Our Ref: 9339/OCK/AMB/L72091
Your Ref: TNS/003277 and
EcoTrack Applic. 471359 Proj. 279643
Council Ref: 8/13/1625
Date: 14 May 2013

**RE: INFORMATION REQUEST RESPONSE PURSUANT TO SECTION 278 OF THE
SUSTAINABLE PLANNING ACT 2009**

**APPLICATION FOR RECONFIGURATION OF A LOT (1 LOT INTO 99 LOTS) ON LAND
LOCATED AT VIXIES ROAD, WONGA, LAND DESCRIBED AS LOT 51 SP155078**

RPS Drawing No.9339-37

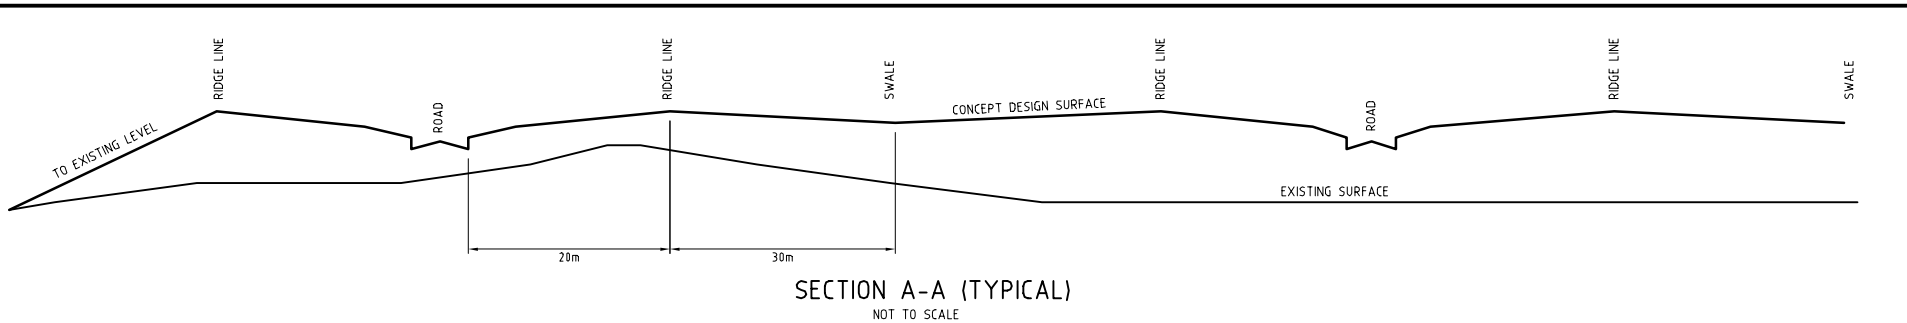
Please provide a map showing the HES wetlands and proposed buffers with an overlay of the subdivision and proposed lots to demonstrate that the development is located outside the mapped boundary of the identified HES wetlands. This map should clearly show the location of all proposed high impact earthworks.

The plan provided for reference in **Attachment A**, RPS Drawing No 9339-37, shows the HES wetlands and proposed buffers with the proposed subdivision overlayed. It is evident from the Concept Filling and Drainage Overlay Plan, that the proposed fill and drainage works and the location of lot boundaries and roads are located outside of the mapped boundary of the HES wetland and as required in response to the Wetlands Assessment provided for reference in **Attachment B**, works associated with the development are located outside the recommended buffer.
